INDIAN RUN DAM

PHASE I INSPECTION REPORT NATIONAL DAM INSPECTION PROGRAM

INDIAN RUN DAM
SCHUYLKILL COUNTY, PENNSYLVANIA
NATIONAL I.D. NO. PA 00696

WOODWARD-CLYDE CONSULTANTS
5120 Butler Pike
Plymouth Meeting, Pennsylvania 19462

SEEPAGE LOCATION PLAN
INDIAN RUN DAM
SHEET 5a OF 11

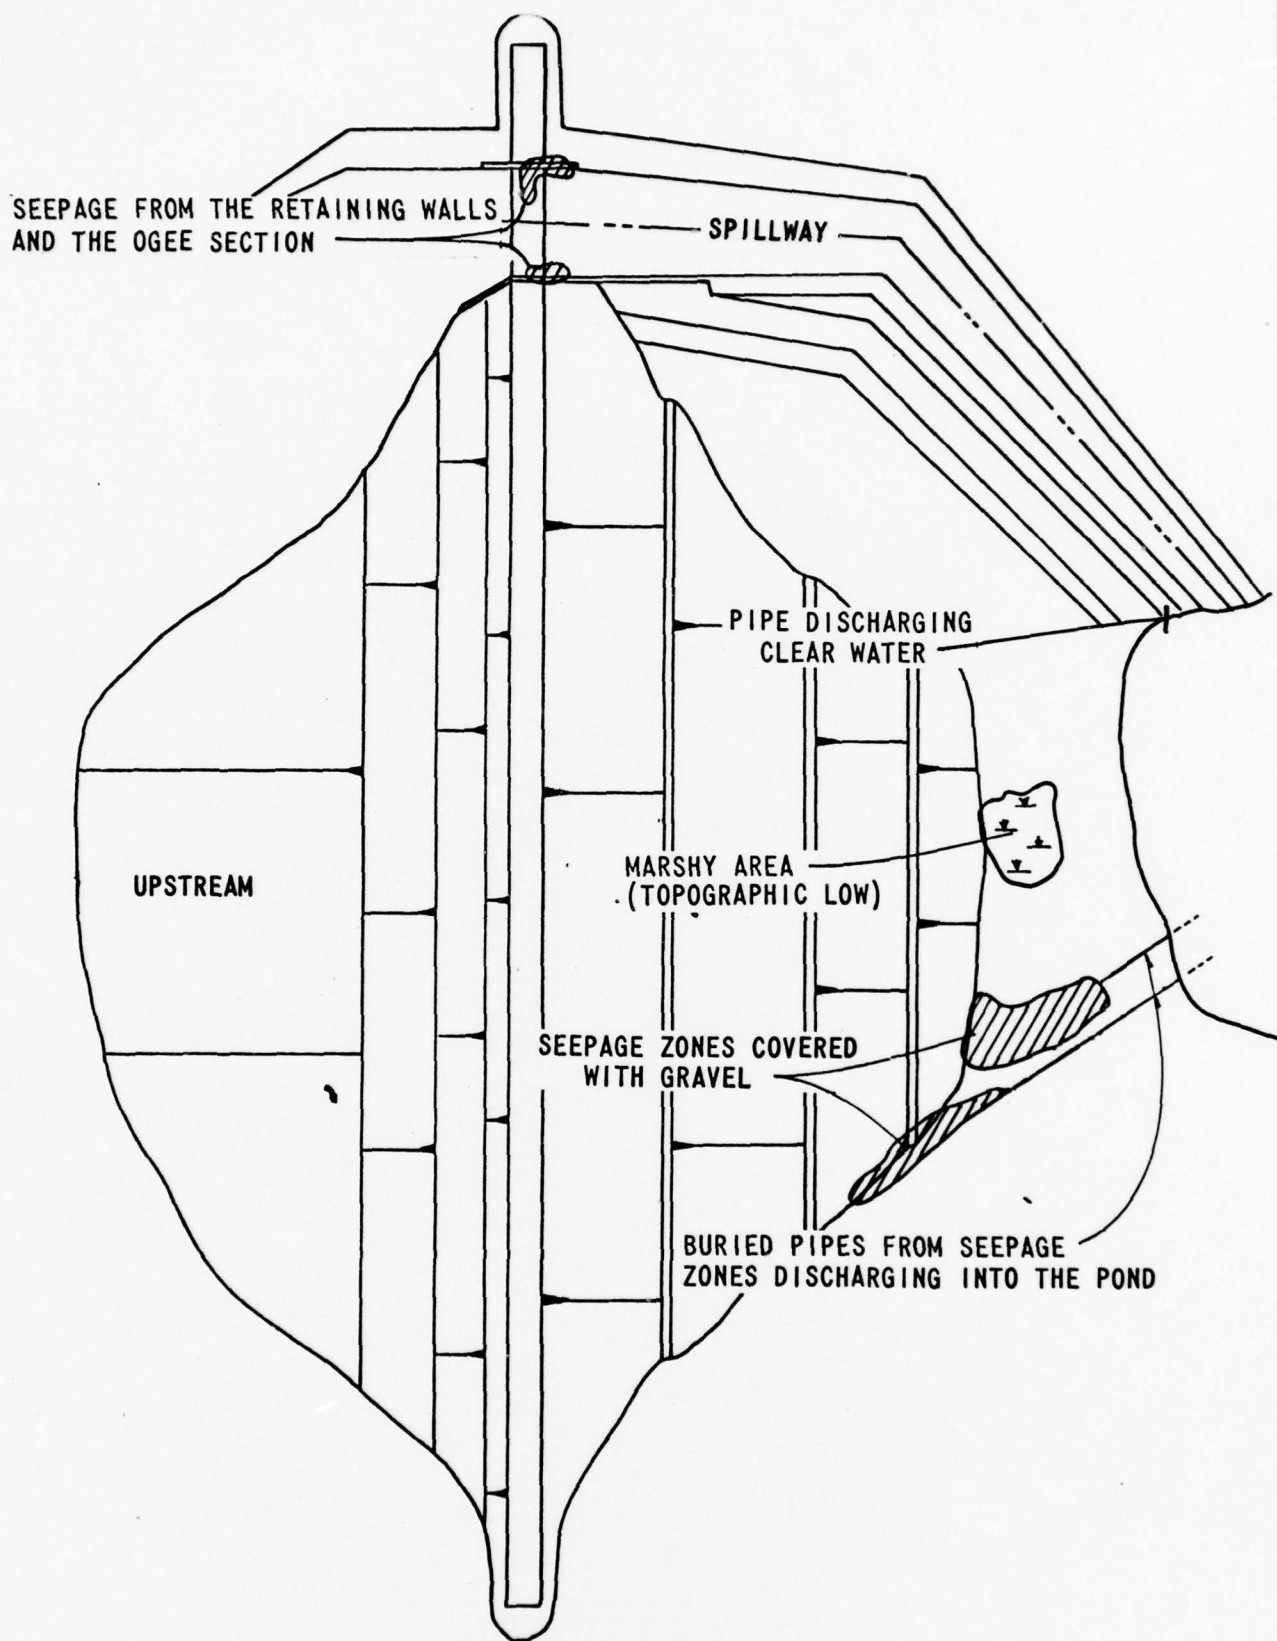
Some seepage was observed along the right abutment of the dam approximately two thirds of the way down the slope. Seepage zones noted in the DER files were found, and observed. They have been excavated; filled with gravel, and drainage pipes now lead to the lower pond. See sheet 5a.

Three drain pipes were noted as shown on sheet 5a.

PHOTOGRAPH NO. 6

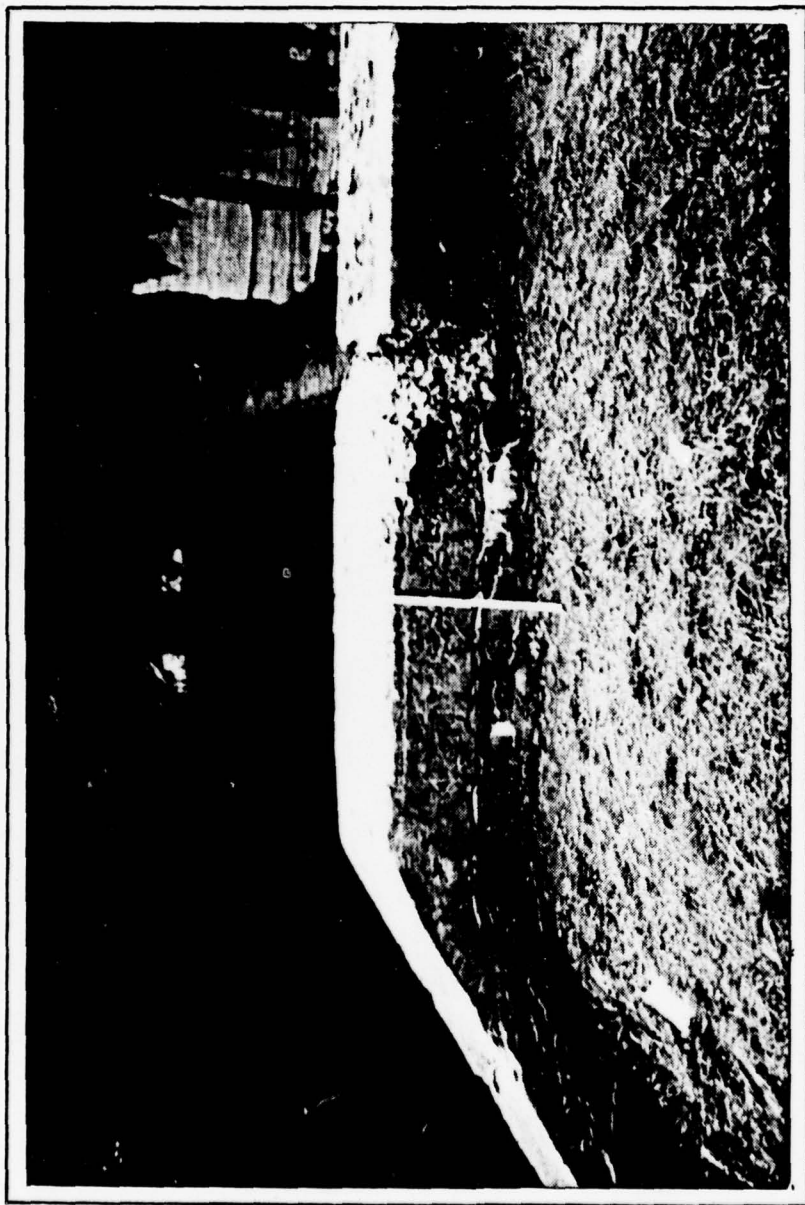
SPALLED CONCRETE OF SPILLWAY WALLS.
NOTE SETTLEMENT OF EMBANKMENT ADJACENT
TO WING WALLS.

PHOTOGRAPH NO. 7

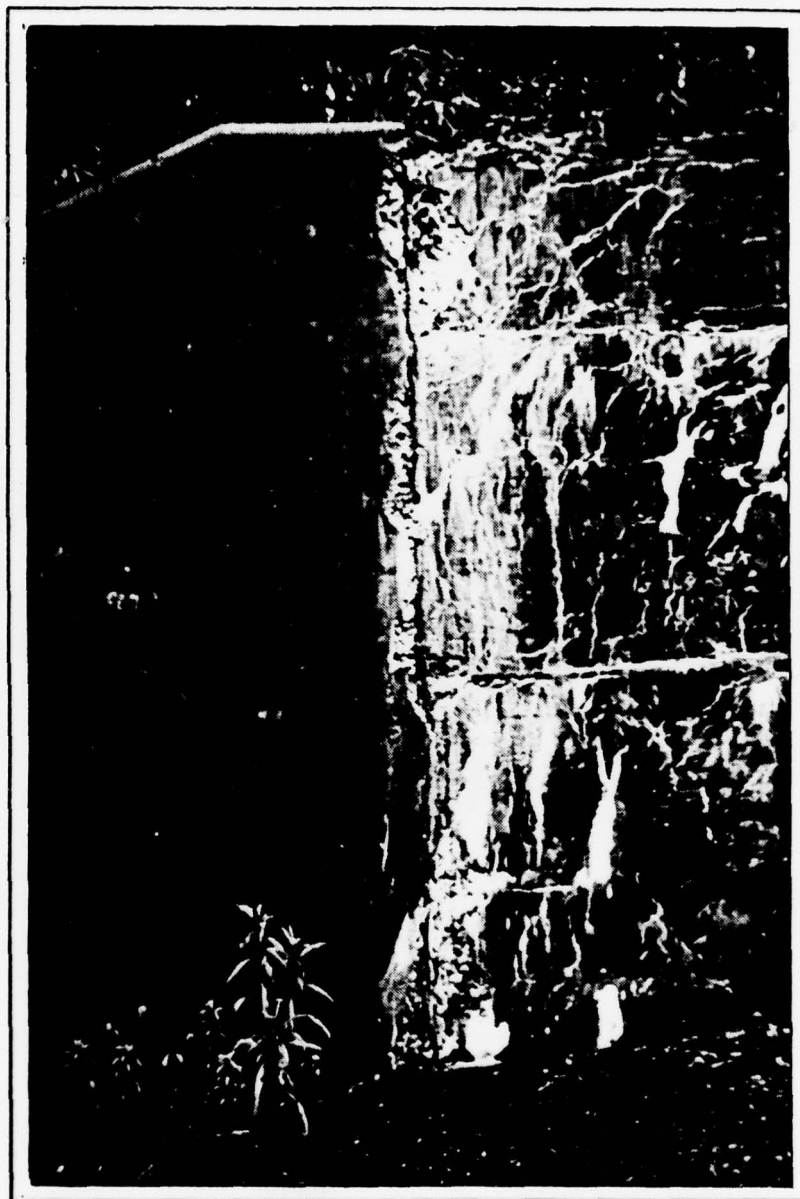
PRINCIPAL SPILLWAY. NOTE CONCRETE
DETERIORATION AND EROSION ADJACENT
TO WING WALLS. DESIGN CALLED FOR
FILL TO TOP OF WALLS.
